# *The Heath & Hampstead Society*

Planning Reference	2014/4332/P	
Address	Hampstead and Highgate chains of ponds, Hampstead Heath, London	
Description	Dam engineering works etc. as described	
Case Officer	Jonathan Markwell	Date 6 August 2014
Response	<b>OBJECTION</b>

Planning Reference	2014/4332/P	
Address	Hampstead and Highgate chains of ponds, Hampstead Heath, London	
Description	Dam engineering works etc. as described	
Case Officer	Jonathan Markwell	Date 12 September 2014
Response	<b>SUPPLEMENTARY OBJECTION</b>

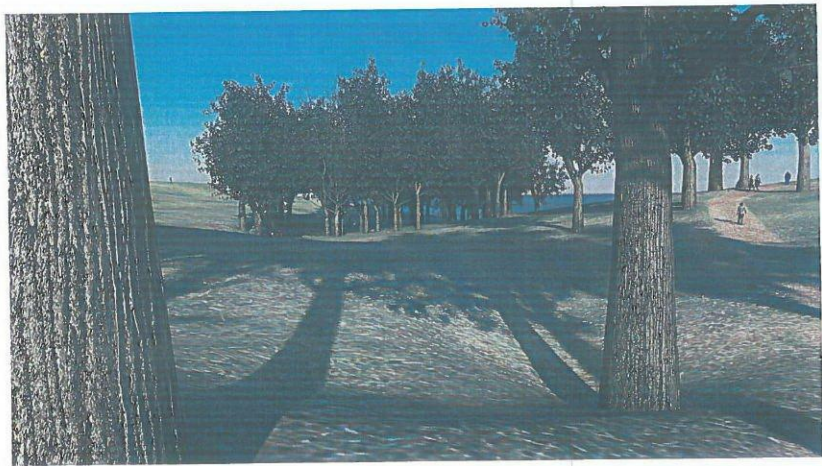
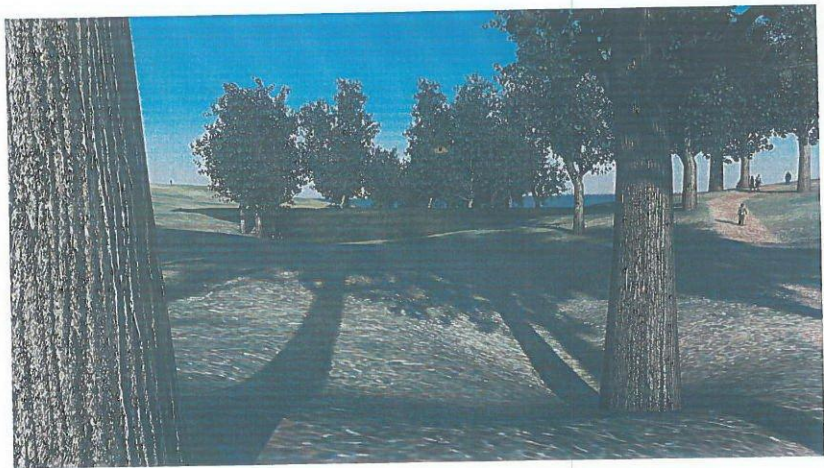
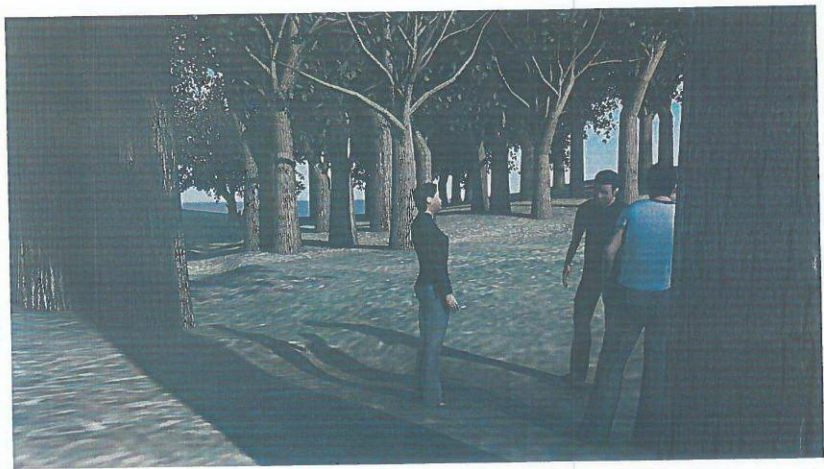
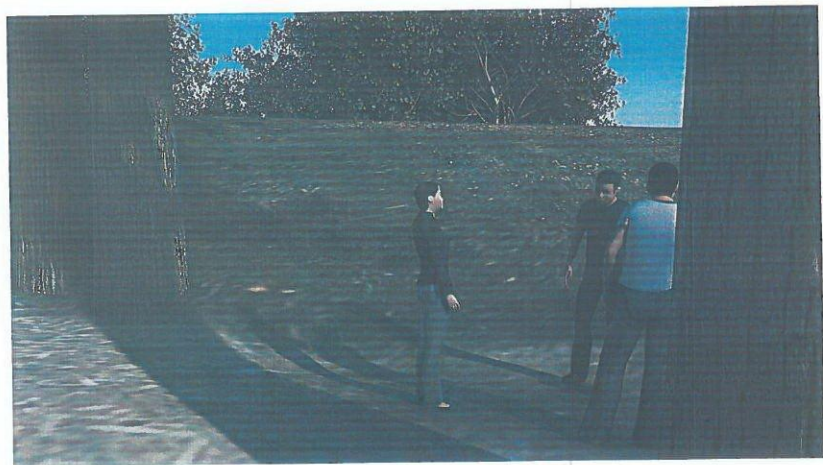
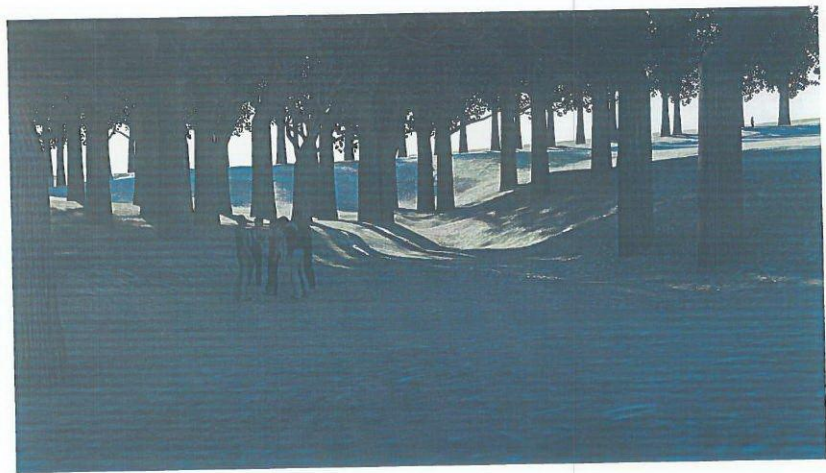
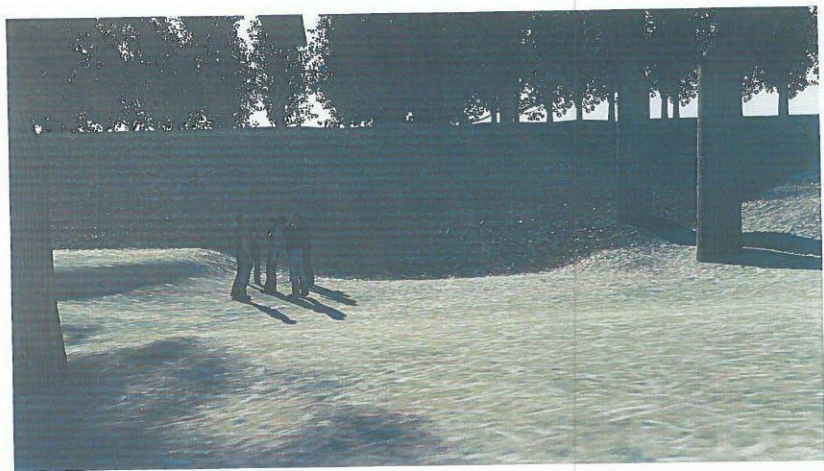
Page 37 of the City's Photomontages purports to show the "after" picture of the (southern) dam on Men's Bathing Pond after construction of the one-metre high wall of sheet piling. The picture is taken from such a distance away, on the north bank of the Pond, that the wall is barely visible. The first part of the electronic visualisation prepared by Wilmac (item (4) of enclosures) shows the dam at the Highgate Men's Bathing Pond before – with the existing wooden picket fence – and after – with the wall – the works. Although the new wall is proposed to be clad, possibly with wood, it is nothing other than an unnatural and unsightly addition to the Heath landscape designed in disregard of the prohibition on enclosing or building upon the Heath contained in section 12 of the 1871 Act. The visualisation shows in particular how the wall will appear to swimmers.

Pages 61 and 63 of the City's Photomontages purport to show "after" pictures (viewed looking eastwards and westwards respectively) of the new "dry" dam at the Catchpit. Again, in the Society's view, the pictures are misleading in that, being taken from a distance, they visually understate the scale of the new dam (100 metres long and 40 metres wide). Indeed the dam is shown as "peeping" through the tree canopy. The second part of the electronic visualisation prepared by Wilmac (item (4) of enclosures) shows the site before and after the dam, to scale and relative to the height of walkers along its base. As Wilmac noted in its letter to the Society (enclosed), both the City's Photomontages are misleading in their depiction of the extent of tree preservation on either side of the dam. The scale of the works will entail extensive tree removal on either side of the dam, as is confirmed in the Development Management Forum Summary prepared by the City.
